Southampton to London Pipeline Project

Responses to Written Representations -
Other Parties

Application Document: 8.24

Planning Inspectorate Reference Number: EN070005

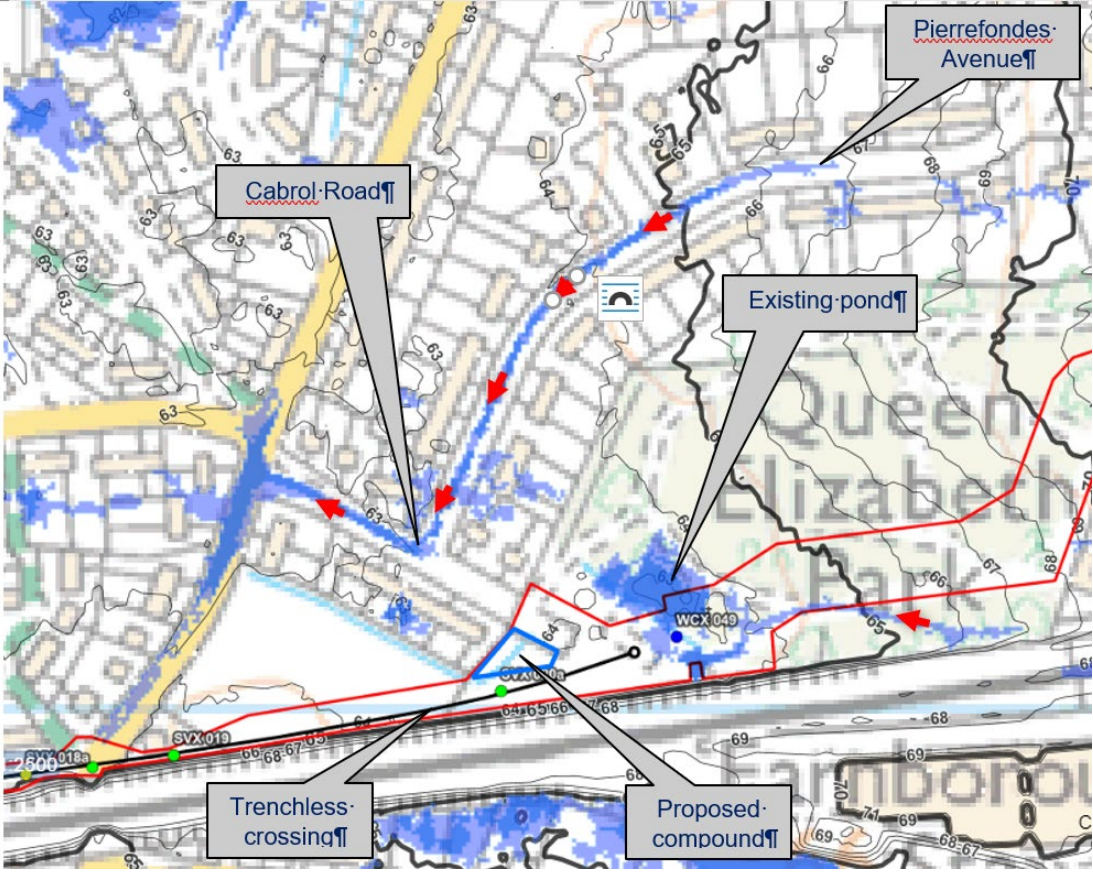
<p>Section 2.2.1 Temporary play area Q5-6</p>	<p>Concerns about the quality and location of the temporary play area.</p> <p>The temporary play area will be substandard compared to the current facility.</p>	<p>The Applicant wishes to reassure the community that while the temporary play area may be different in terms of the equipment and location within the park, the provision will be agreed with the Council and the Applicant will commission an experienced and professional company to install it.</p> <p>As per the commitment outlined above, the Applicant has committed to installing a temporary play area within the Order Limits within the park, if a suitable alternative location is not agreed with Rushmoor Borough Council.</p>

WR Para Ref	Point raised	Applicant response to point raised:
	<p>The temporary play area will be too far away from the current one to be accessible by the current users.</p>	
<p>Section 2.2.2 New play area Q1-2</p>	<p>Concerns about the size and location of the new play area.</p> <p>1.The route of the pipeline will impose restrictions on where the new playground can be sited and what it can contain.</p> <p>2.The new play area will not be in the same location as the existing one.</p>	<p>In response to point 1, Rushmoor Borough Council actively engaged Esso before the installation of the existing play area, as it is partly within the easement of the existing pipelines within the park. There is no evidence to suggest this would not be possible with the replacement pipeline.</p> <p>In response to point 2, the Applicant can confirm that the reinstated play area will be in the same location as the existing one.</p>

WR Para Ref	Point raised	Applicant response to point raised:
		<p>Figure 1.1: Current understanding of Cabrol Road Surface Water Flood Risk based on RoFSW Mapping for 1 in 30 (dark blue) and 1 in 100 (light blue) events</p>

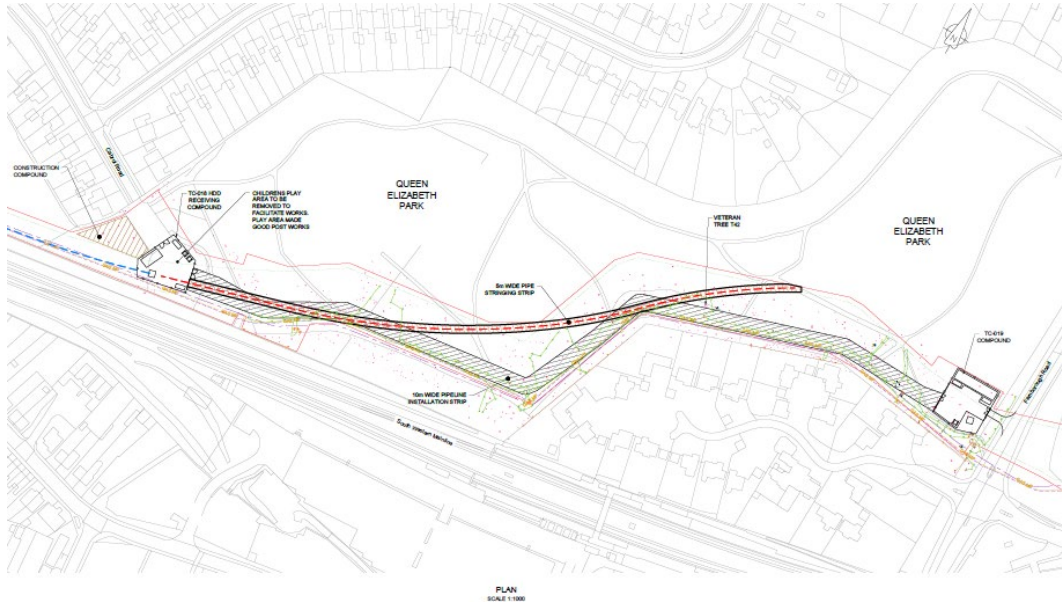
WR Para Ref	Point raised	Applicant response to point raised:
	<p>trees in the park will result in increased flooding in Cabrol Road.</p> <p>4.The construction compound and the activities within it will contribute to an increased risk of flooding in Cabrol Road</p> <p>5.The lower end of the park and gardens in Cabrol Road will be generally wetter all year round due to decreased drainage capacity during and after the project.</p>	<p>Queen Elizabeth Park. This second flow path appears to enter the pond at the western end of the park. When considering the 1% (1 in 100 (Medium)) Annual Exceedance Probability (AEP) extent this flow path does not appear to extend into Cabrol Road.</p> <p>The Rushmoor Borough Council Strategic Flood Risk Assessment (SFRA) (2015), makes no reference to flood history in relation to Cabrol Road based on historic reports provided by the Environment Agency, Hampshire County Council or Rushmoor Borough Council.</p> <p>There would also be no impermeable surfaces introduced during the construction phase.</p> <p>During construction the Applicant does not anticipate having an effect on the flood flow path along Pierrefondes Avenue. The southern flow path through Queen Elizabeth Park is less defined where it enters the Order Limits and the Applicant does not anticipate its work in this area contributing to flows. While the Applicant expects to remove some trees in the southern part of the park, removal of trees would not change the nature of the ground surface, and the ground would remain permeable. Therefore, the project would not change surface water runoff rates as a result of the removal of the trees.</p>

WR Para Ref	Point raised	Applicant response to point raised:
<p>Section 2.3.1 Flooding in Cabrol Road Q6</p>	<p>Concerns about mitigation for flooding and impacts of the construction compound.</p> <p>6. Waste and pollutants within the construction compound could contaminate gardens in Cabrol Road if they are carried off by heavy rain, flooding, or general run off.</p>	<p>In response to point 6, the Applicant does not anticipate that waste and pollutants from within the construction compound could contaminate the gardens of Cabrol Road. There are measures within the CoCP to protect against such events occurring, primarily by implementation of the following mitigation measures:</p> <p>A Construction Environmental Management Plan (CEMP) would be produced in line with the outline CEMP , to be submitted at Deadline 4. It would explain how the activities of sub-contractor(s) comply with its requirements and include subsidiary plans such as the management of waste and soils (commitment G1).</p> <p>The CEMP would include pro-active actions and measures to control pollution risks. This could be either directly from the construction works or due to external factors such as extreme weather. Measures would include appropriate storage and handling of fuels and other substances hazardous to the environment (commitment G8).</p> <p>All refuelling, oiling and greasing of construction plant and equipment, would take place above drip trays and also away from drains as far as is reasonably practicable. Vehicles and plant would not be left unattended during refuelling. Appropriate spill kits would be made easily accessible for these activities (commitment G121).</p> <p>The Applicant would comply with all relevant consent conditions or DCO provisions regarding de-watering and other discharge activities. This would particularly be with regard to volumes and discharge rates and would include discharges to land, waterbodies or third-party drains/sewers (commitment G128).</p>

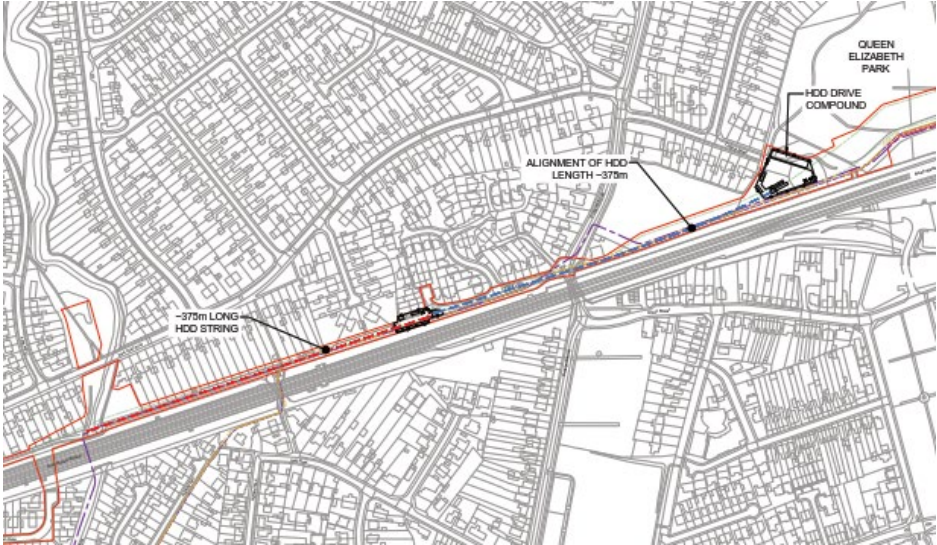
<p>Section 2.4.2 Tree loss due to stringing out area</p>	<p>1.The stringing out activities and their effects on the park are not documented.</p> <p>2.Stringing out will require the clearance of trees.</p> <p>3.The area cleared for the stringing out activities will be separate from and in addition to any area cleared for trenchless installation (if trenchless installation is used).</p>	<p>In response to point 1, the effects on the park have been fully assessed as a worst-case scenario in the Environmental Statement. Further design detail on the installation methodology is being provided at Deadline 4.</p> <p>In response to point 2 (please refer to ISH2-11 (Document reference 8.20)), some of the younger trees and scrub around the pond would need to be removed, but the mature trees to the east of the pond are well spaced and the Applicant is confident these will not need to be removed.</p> <p>Point 3 is correct. To reduce impacts to trees the Applicant intends to install near the existing pipeline and the path. These both follow the southern boundary of the park, which is not straight. The Applicant then needs a single length of pipe the same length as the trenchless section (from Stake Lane into the park) which needs to be laid out on rollers above the ground so it can be pulled back through. This would be a mostly straight working area.</p>

WR Para Ref	Point raised	Applicant response to point raised:
	<p>4.Narrow working width commitments do not apply to stringing out.</p> <p>5.The exact area to be used for stringing out is not documented.</p> <p>6.Stringing out could require the closure of additional areas of the park.</p> <p>7.The environmental and visual impact statements do not take into account the damage caused by stringing out.</p> <p>8.Mitigation commitments do not cover damage caused by stringing out.</p> <p>9.Esso have not considered reversing the direction of drilling to avoid stringing out within the park.</p>	<p>In response to point 4 the narrow working applies to all works undertaken in the designated sections.</p> <p>In response to point 5, the Applicant is submitting a draft plan to illustrate the 10-metre maximum working area for the open-cut installation and the 5-metre maximum stringing area.</p> <p>In response to point 6 the Applicant is only seeking permission within the Order Limits. The Applicant has committed to a 10-metre-wide working area for open-cut installation and a 5-metre-wide area for stringing through the park to reduce the impact on trees and users of the park.</p> <p>In response to point 7 the Applicant has assessed a worst-case scenario in the Environmental Statement. This covers all activity related to the project.</p> <p>In response to point 8 mitigation commitments cover all works. In addition, stringing is a low impact activity as it is above ground and the pipeline is laid out on rollers.</p> <p>In response to point 9, reversing the direction of drilling was considered and discounted on the basis that it would require stringing along and behind the back gardens of the properties along West Heath road, this would then require vegetation and tree clearance at the base of the railway embankment. The replacement pipeline along this section of the route is being installed by trenchless construction (TC017) to avoid the need for such an event and also to limit the impact on the residents, hence it would not make sense to then impact the residents with pipeline stringing works for TC018. The lengths of pipe material (12m long) to create the string for TC018 in this proposal will have to be delivered to the work site in Stake Lane and a ‘workshop’ area created to weld the lengths together in this location to limit the impact on the residents back gardens of West Heath Lane, and therefore the duration of the works to the area of the former garages of Stake Lane will be considerably longer, with more deliveries for the residents of Stake Lane and Brewers Close. The Applicant has considered that for efficiencies utilising the drive pit from the same location at Stake Lane does mean that the drive unit only needs to be turned around</p>

WR Para Ref	Point raised	Applicant response to point raised:
		<p>in the same location and there is not the requirement to build another drive pit in QEP. To move the drive pit to the play area of the park would introduce a larger mobilisation of plant to the park location. This would result in a larger drive compound and the loss of trees in the south west corner. See sketch below (Figure 1.3).</p> <p>Figure 1.3 – HDD from play area in QEP to Stake Lane</p> 
<p>Section 2.4.3 Tree identification</p>	<p>1. Esso has not produced detailed tree identification records for Queen Elizabeth Park. 2. Lack of detailed tree records prevents the extent of the damage</p>	<p>In response to point 1, the Applicant has provided Appendix 10.2 Schedule of Notable Trees – Revision No. 2.0 (REP2-009) that shows that the trees within Queen Elizabeth Park have been identified as a notable group. Notable trees are defined by the Applicant as prominent trees within the landscape and by nature will generally be the large, mature specimens.</p>
